LODI UNIFIED SCHOOL DISTRICT

TOKAY HIGH SCHOOL ASPHALT PROJECT NUMBER: 8150-5830-2

ADDENDUM NO. 3

December 1, 2022

C3.01 - ADD 3

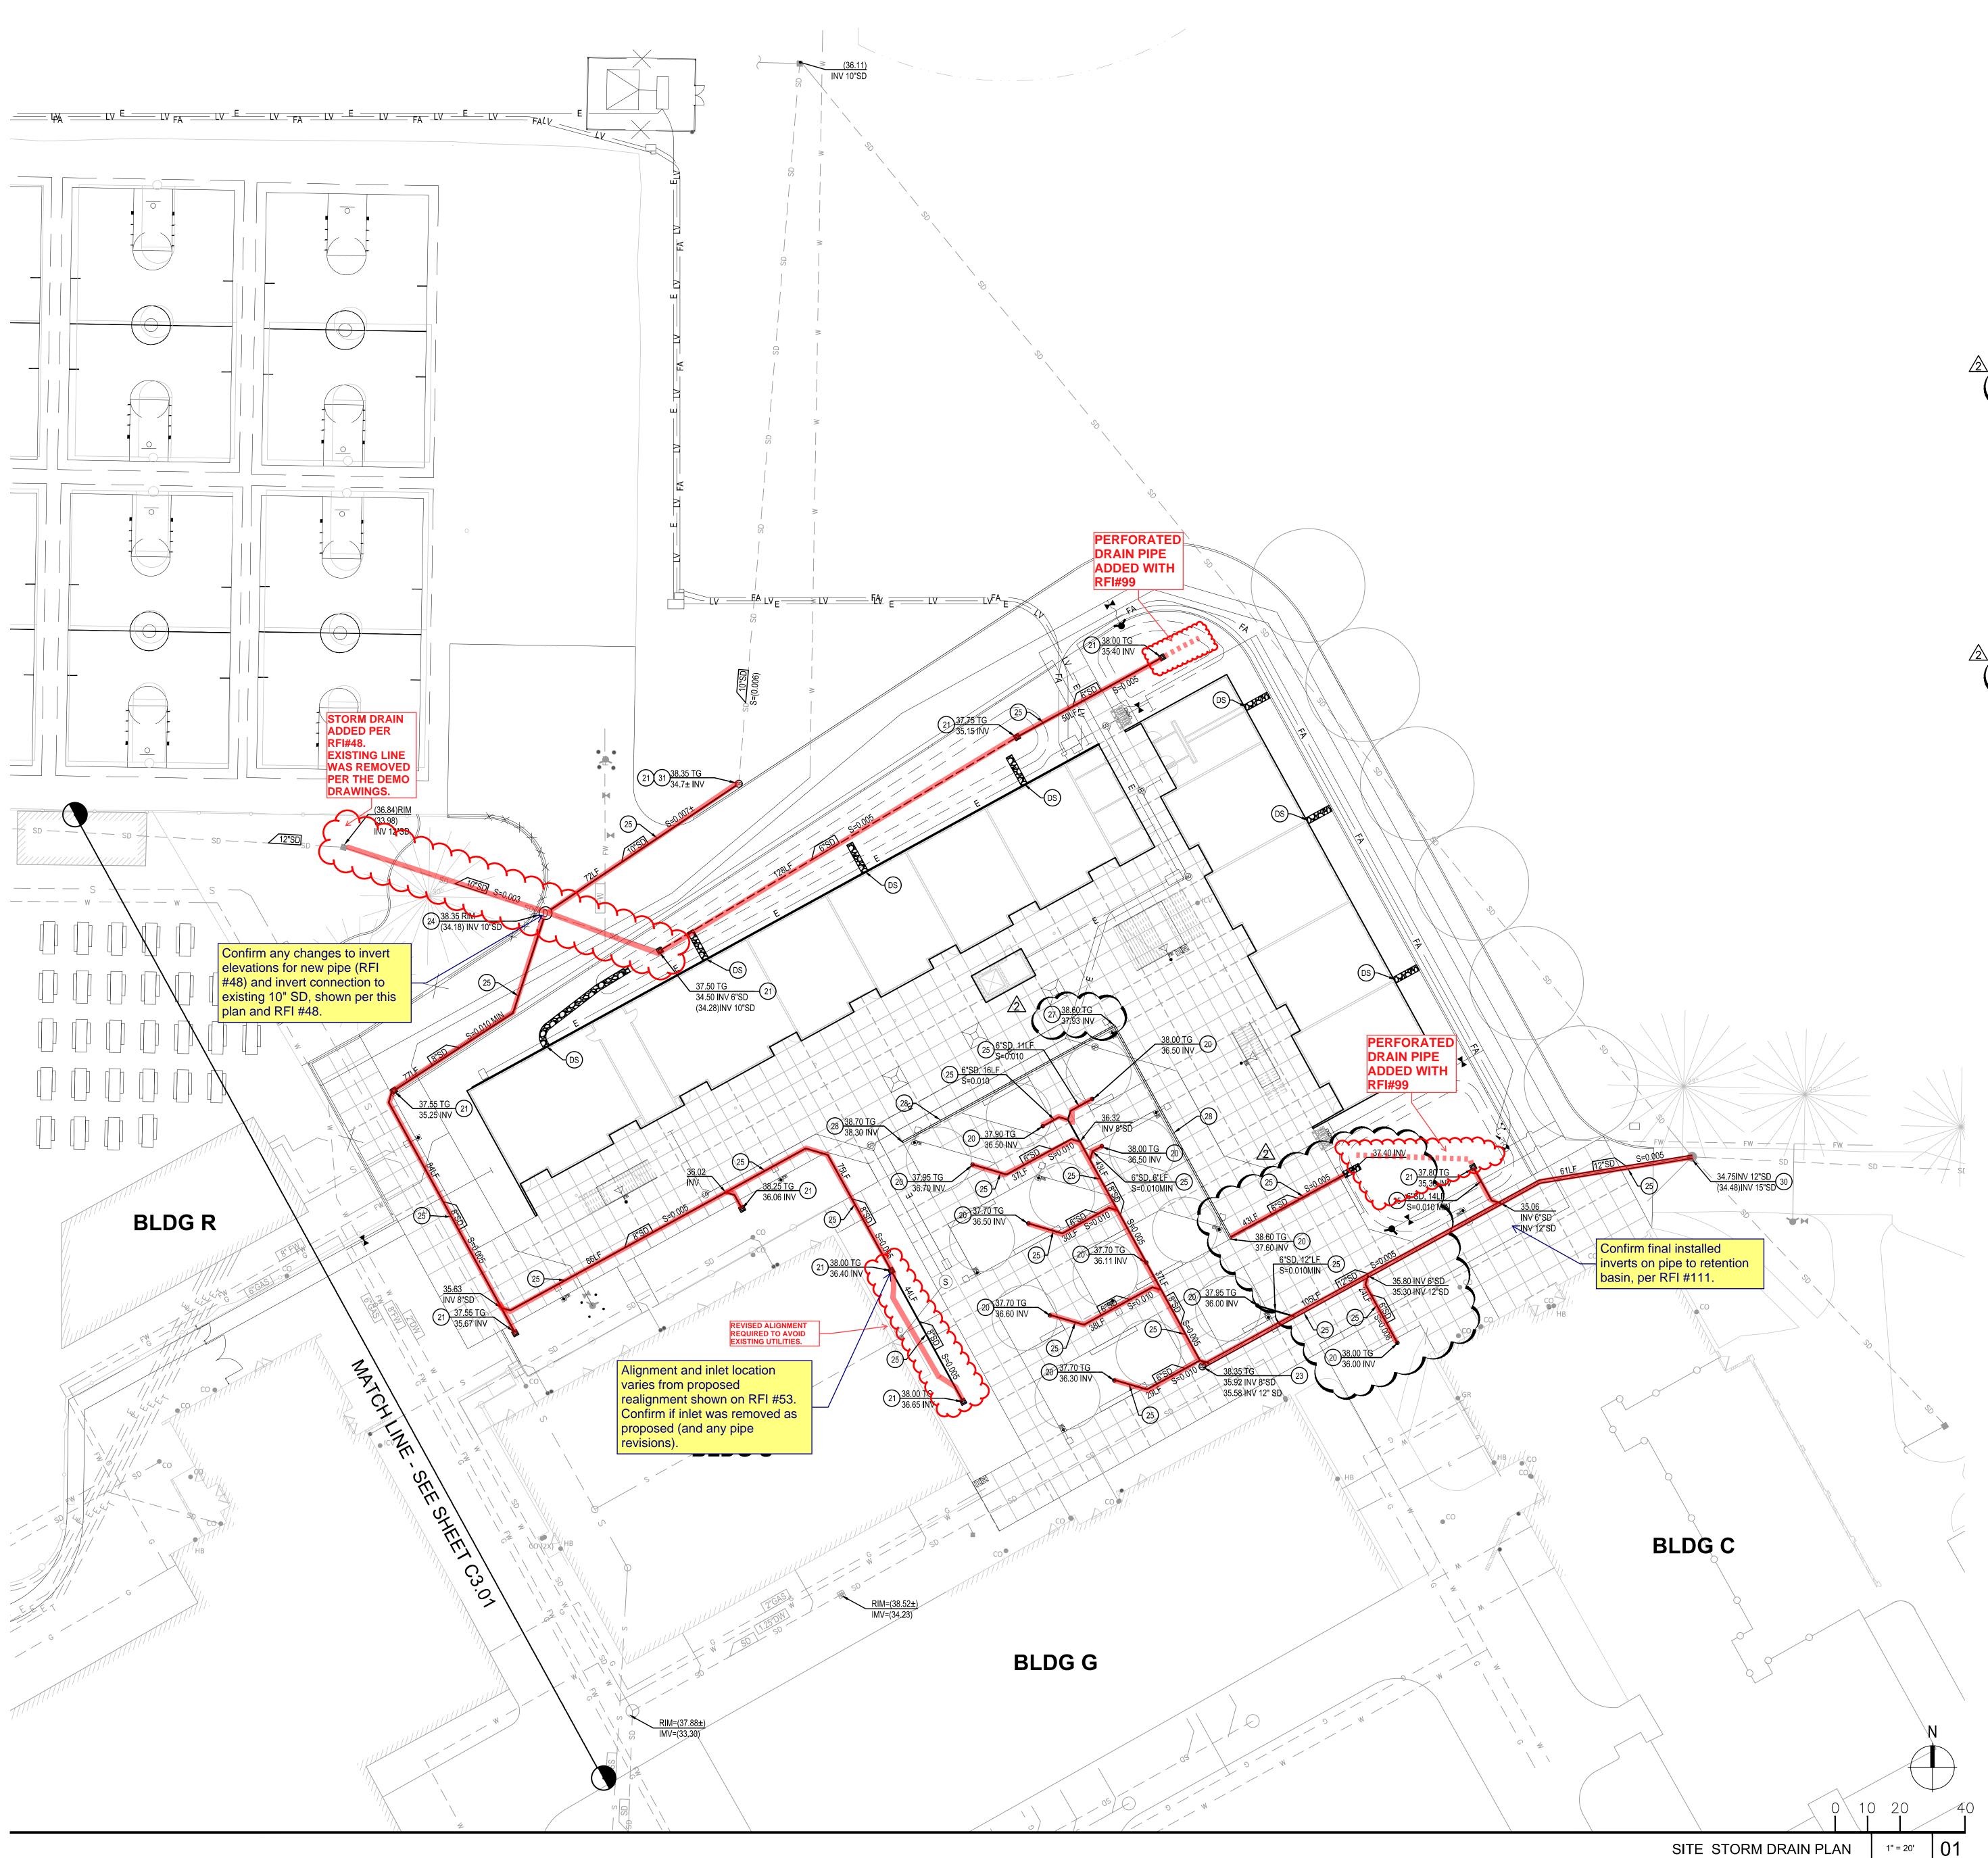
QUESTION: Are there any available as built drawings that may show the invert of the existing drainpipe that we will be connecting to as well as current pipe diameter, existing catch basin dimensions? If not, can a site visit be granted for a field verification? **RESPONSE:** Civil As-Builts are included as requested. A non-mandatory site visit will be granted, to be be held Friday, December 2, 2022, at 10:00 a.m. at Tokay High School, 1111 W. Century Blvd., Lodi, CA 95240. All participants please meet at the Flagpole in the front of the school.
